## SERVICE BULLETIN

**FEBRUARY 14, 1989**

# SAFETY RECALL CODE 065 1988/1989 RLE.TLE SIDECARS BRAKE SIDE PLATE

M-974

Figure 1. Wheel Assembly

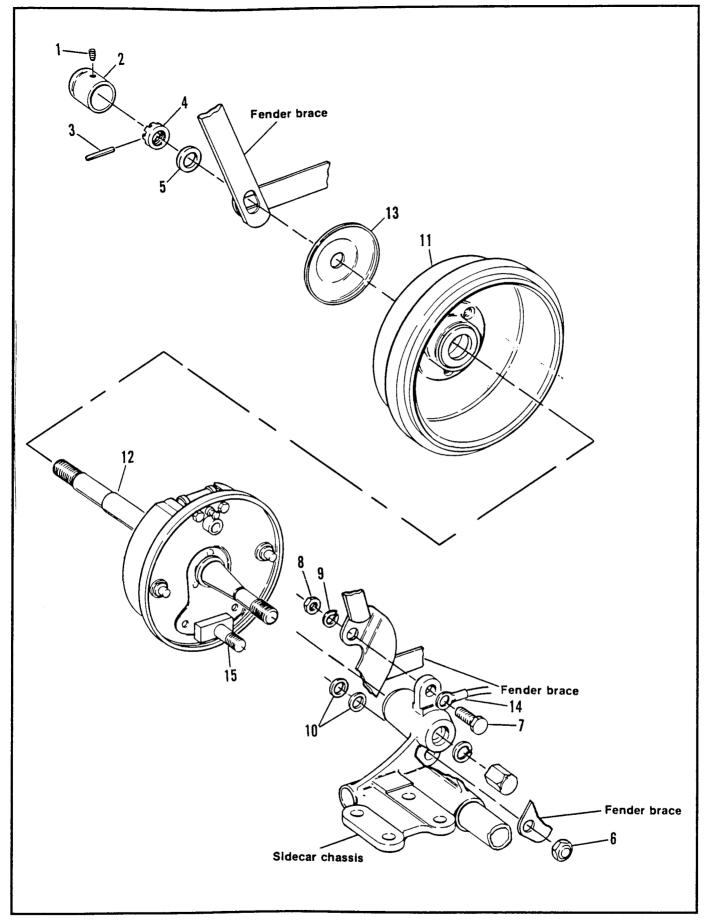
- Raise and block sidecar chassis so wheel may be removed.
- 2. See Figure 1. Loosen setscrew (1) in axle cap (2).
- 3. Remove axle cap (2), rollpin (3) axle nut (4), and washer (5).
- 4. Remove locknut (6) bolt (7), nut (8) and lockwasher (9).
- Cut cable straps attaching fender light wire and brake line to fender braces. Remove fender and wheel.

- See Figure 1. Install wheel assembly (11) on axle (12).
- 2. Install hub cap (13), if equipped, on axle.
- 3. Install fender. The outer fender braces fit over the axle. Fasten inner fender support and ring terminal (14) of directional light ground wire to the chassis with fasteners (7,8 and 9). Tighten to 24 ft-lbs torque.
- 4. Secure inner fender brace with locknut (6). Tighten to 85 ft lbs torque.
- 5. Install castle nut (4) and tighten to 38 ft-lbs torque. Insert roll pin (3) and install cap (2).
- Attach fender light and brake line to fender braces with cable straps

Figure 2. Side Plate Assembly

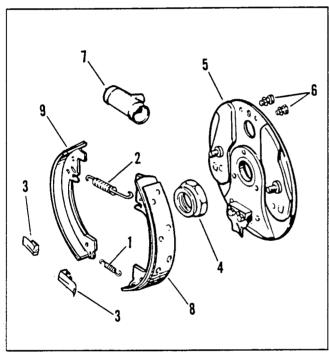
Harley-Davidson has become aware that the possibility exists that during the assembly of rear brake side plate assemblies used on 1988 and 1989 TLE and RLE sidecars, curved spring washers and/or flat washers may have been omitted from some of the side plate assemblies.

The absence of one or both washers theoretically could allow the eccentric to rotate, under certain circumstances, positioning the sidecar brake shoe in a full retracted position and therefore initially resulting in decreased rear braking performance. The motorcycle front brake, separately controlled by the right hand lever, would not be affected under any circumstances.

- 1. See Figure 2. Remove hold-down springs (3) and springs (1) and (2). Remove shoes (8) and (9).
- Apply a liberal coat of penetrating oil to the threads of brake line connection at back of side plate. Disconnect brake line tubing nut from flared fitting at wheel cylinder. Remove nut (4) securing the side plate to axle. Remove side plate assembly (5) and washers (10 Figure 1).

- Remove the two screws and lockwashers (6) attaching brake cylinder assembly to side plate.
- Take the brake cylinder removed from original side plate and attach to new replacement side plate with screws and washers (6). Tighten screws to 50-80 in lbs torque.
- See Figure 1. Place washers (10) on anchor stud (15).
   See Figure 2. Install side plate assembly on axle and thread on nut (4). Tighten nut to 20-30 ft lbs torque. Thread tubing nut onto flared fitting at wheel cylinder. Tighten nut.

(3). Grease area where shoes come in contact with side plate.
- Insert hooks at ends of spring (1) into holes at lower ends of shoes (8 and 9). Position shoe assembly so that shoes straddle plate anchor block at bottom of side plate. Install top spring (2) with short hook inserted in elongated hole on front shoe. Install hold -down springs (3).
